Date: April 6, 2018

Re: Proposal for a Hotel on Broad Avenue

The proposal does not clearly meet setback requirements:

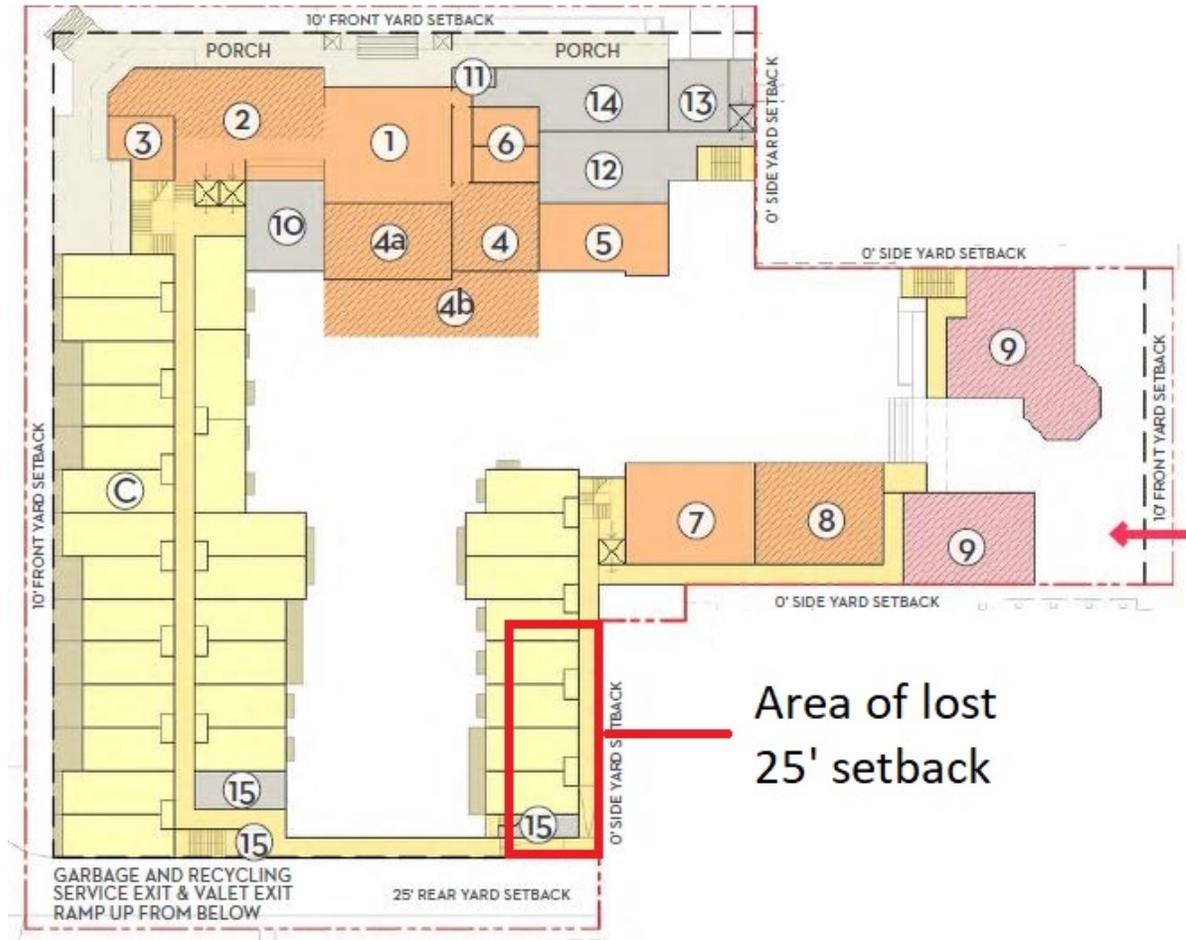
- Concerns for PAB and City Council review**
- The applicant claims three front yard setbacks of 10' along Gordon, Broad and Third per 20_Supplemental_Submittal_-_Architectural_r.pdf
 - The applicant claims a single 25' rear yard setback serving as the exit ramp from the parking/waste area.
 - All remaining boundaries are deemed 0' side yard setbacks.
 - The Naples Code does not generally define how much structure can be placed in a setback area, so the ramp and its attendant screening must be reviewed in this light
 - A significant portion of 25' rear setback is lost when compared to the existing use.
